Field Modification FM20003A

NV Series Transmitters: Replacing UG69* with NAS70* Power Supply Adapter

Issue 1.1 .....01 October 2026

Figure A-1: Locations where the NAS70* cannot be installed

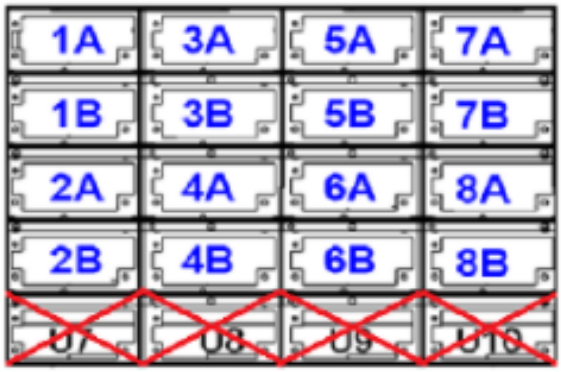
The following graphics indicate the power supply locations inside the NV series transmitter where the NAS70* Power Supply Adapter with integrated UG132 power supply module ***cannot*** be installed because of the AUI/Cooling modification installed on the inside of the front door that mounts the 17” AUI touchscreen. See Figures A-1 and A-2 and Tables A-1 and A-2.

In the NV30/40 transmitters, the NAS70 Power Supply Adapter **cannot** be used in IPA C (U11) position (not shown in Figure A-1, Conflict B).*

Figure A-2: Release 2 NV Series Transmitter Cooling Modifications

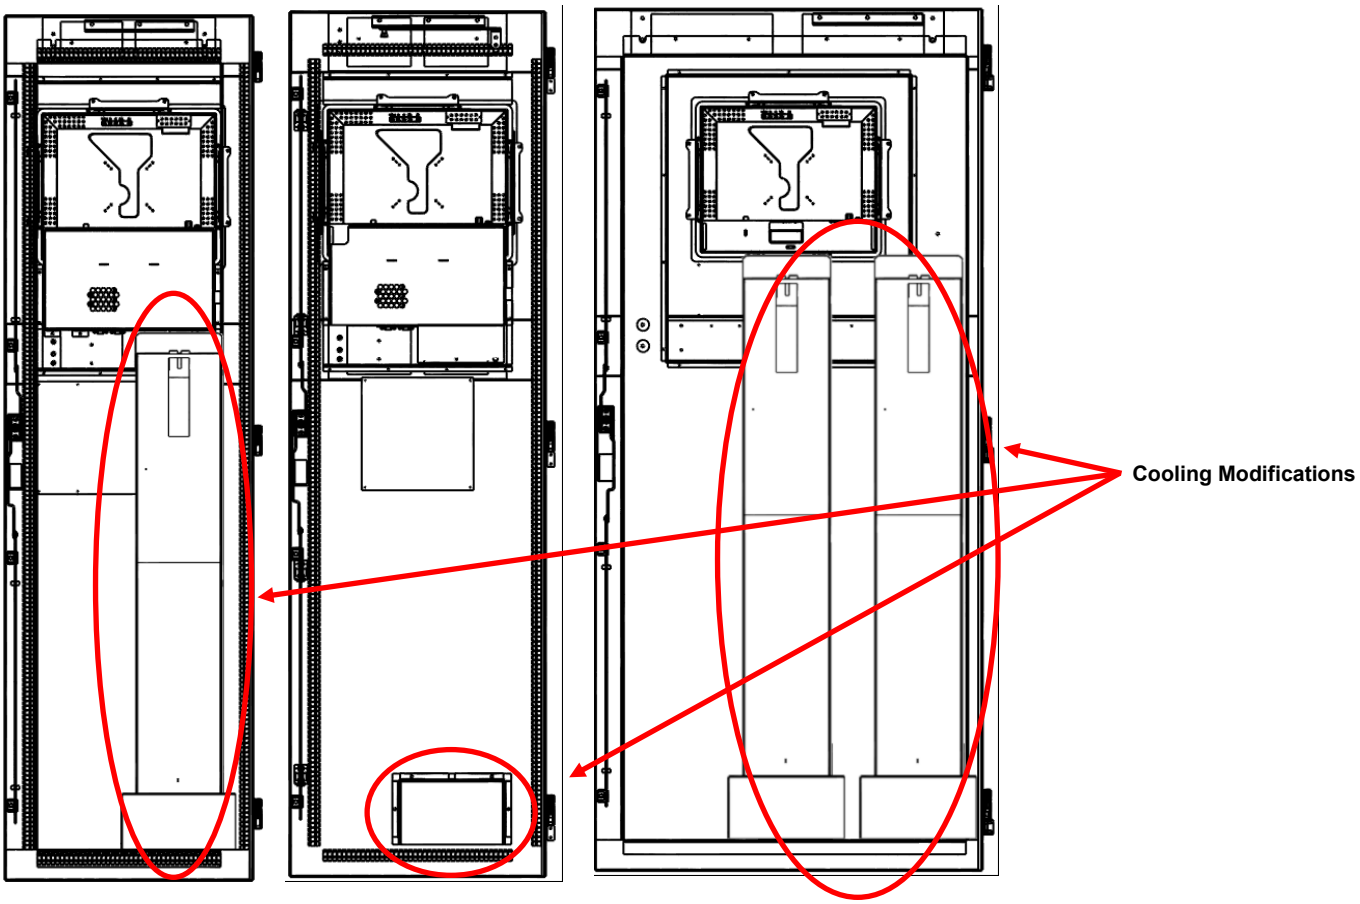
Release 2 NV transmitters were factory configured with a front door having integral blowers installed to cool the AUI touchscreen and SBC. An intake duct that restricts air flow into NAS70 adapters is installed in conflicting regions specified in the Conflict Figure referenced. See Figure A-2.*

Release 3 NV transmitters with DWA11-219 incorporated were factory modified with a front door that has a box attached near the bottom of the door (middle option in Figure A-2). This box prevents air flow from the bottom four power supply modules.

Electrical Schematic – Power Supply Adapter Module (NAS70*)			
FM20003A – Manual Replacement Page	Not to Scale	Figure SD-2A	Page 1 of 1

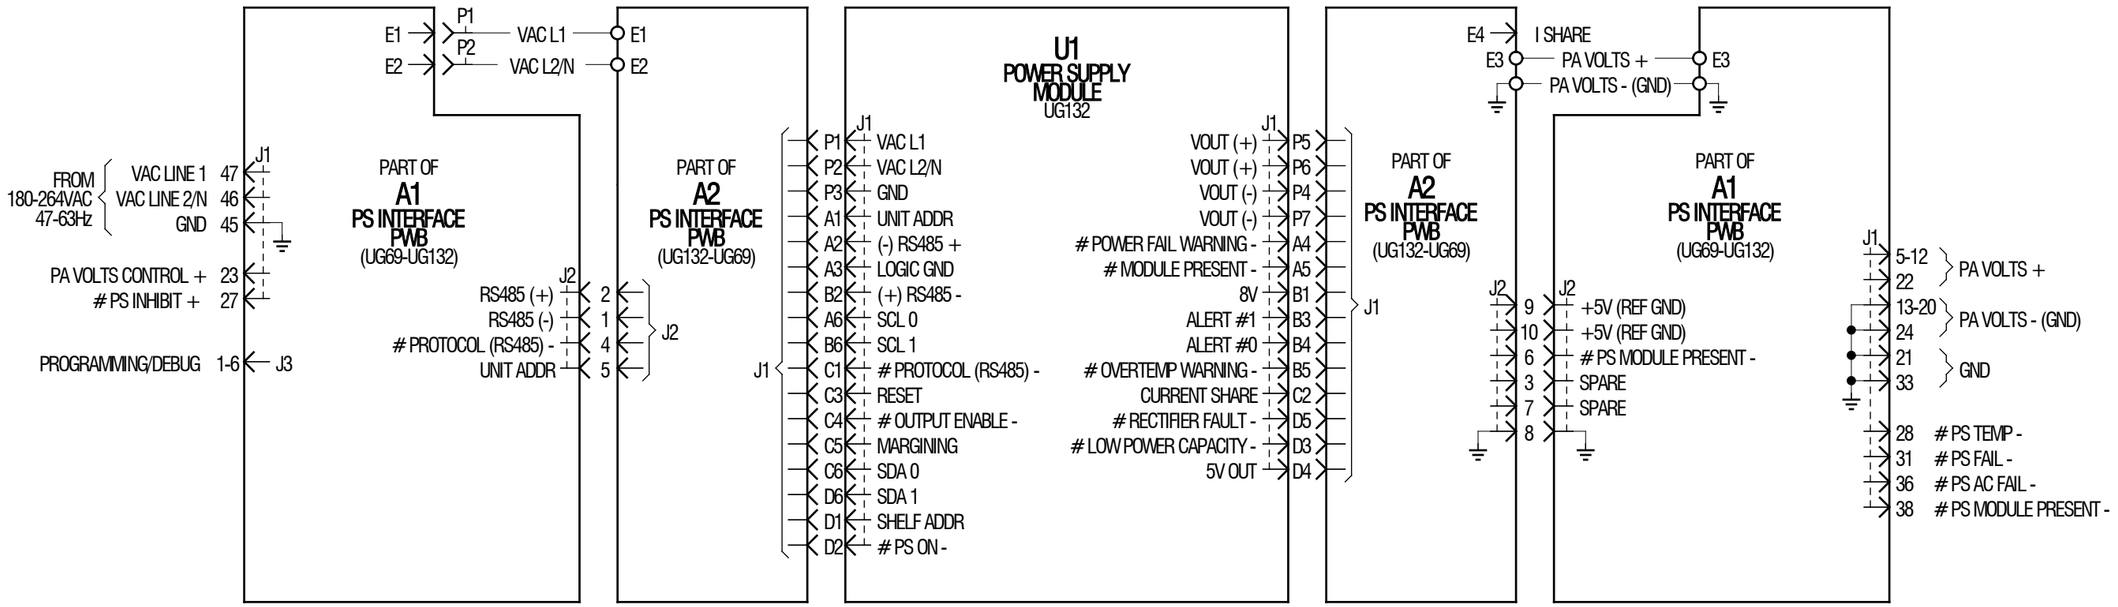
Section 5: Electrical Schematics: The existing Electrical Schematic SD-2 shows power supply module blocks (e.g., for NV3.5/NV5, U9 for power supply module IPA A or U12 for power supply module A) that interface with an associated PS Interface PWB (e.g., A10 or A19) via the power supply module's blind-mate connector J1. After the UG69* power supply is replaced by the NAS70* Power Supply Adapter, note that this connector changes to A1J2 (from J1), for each power supply affected. Electrical Schematics SD-2A to SD-2C are provided with this document to show the detail of the Power Supply Adapter (NAS70*) and its internal Power Supply Interface PWB's (NAPI177 and NAPI178). Print and add these schematics after Figure SD-2 in the Troubleshooting Manual.

Assembly Detail – NAPI177 Power Supply Interface PWB (UG69*-UG132)			
FM20003A – Manual Replacement Page	Not to Scale	Figure MD-A	Page 1 of 1

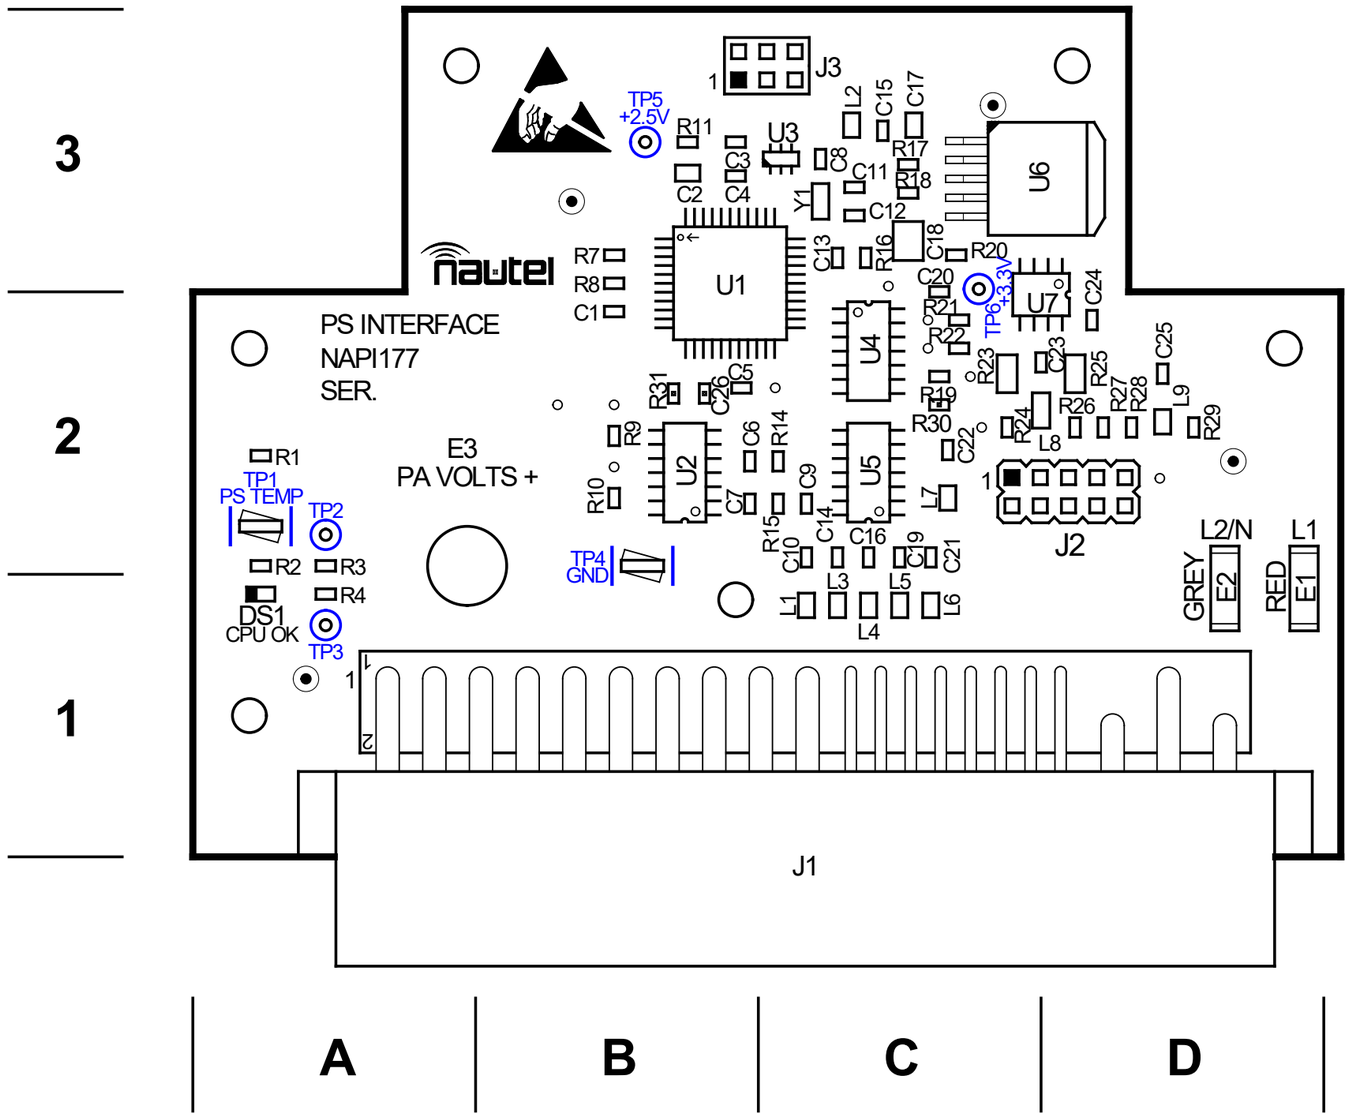
Section 6: Mechanical Drawings: Mechanical drawings MD-A, MD-B and MD-C are provided with this document to show the assembly detail of the Power Supply Adapter module (NAS70*) and its internal Power Supply Interface PWBs (NAPI177 and NAPI178). Print and add these mechanical drawings to the end of the existing mechanical drawings of the Troubleshooting Manual.

Assembly Detail – NAS70* Power Supply Adapter Module			
FM20003A – Manual Replacement Page	Not to Scale	Figure MD-C	Page 1 of 1

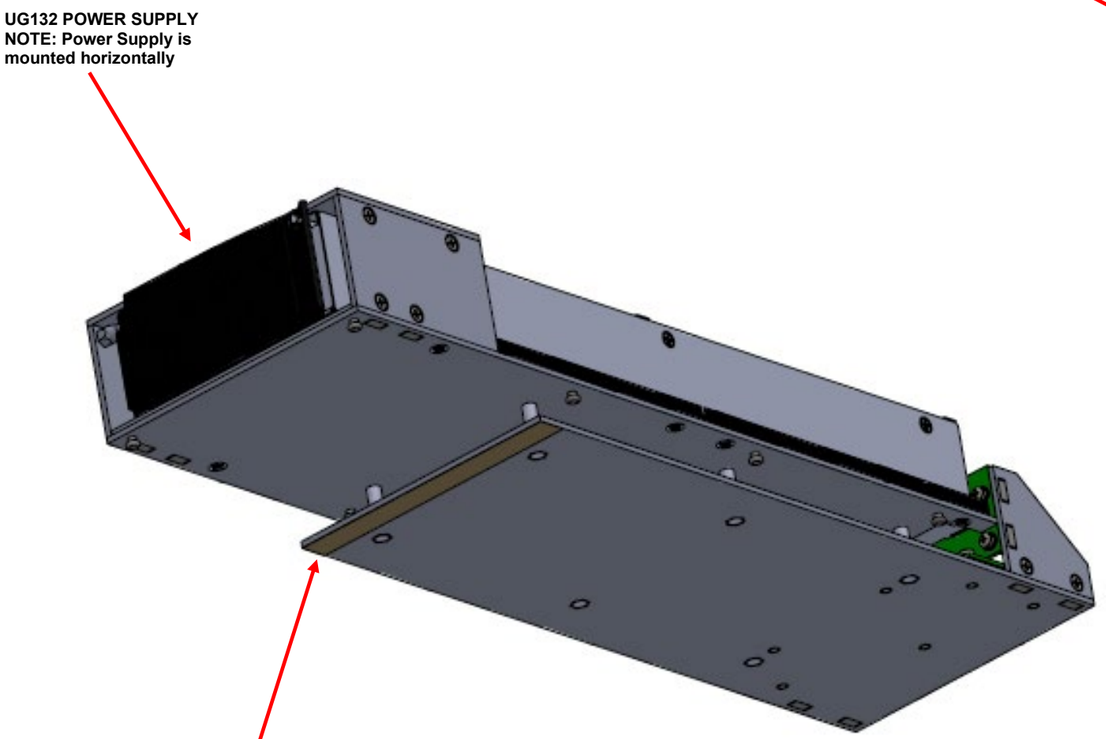
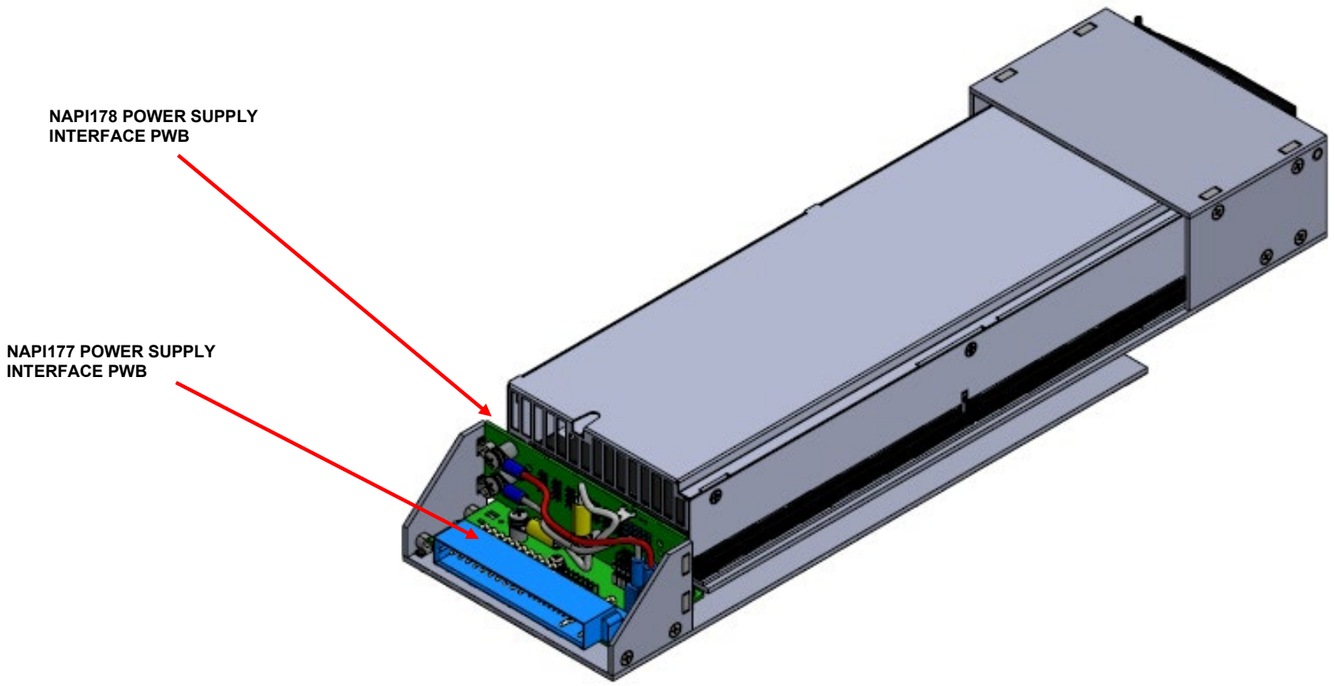
(d) Remove a small corner of the backing strip from the double-sided tape that is attached to the NAS70* Power Supply Adapter. See Mechanical Drawing MD-C.
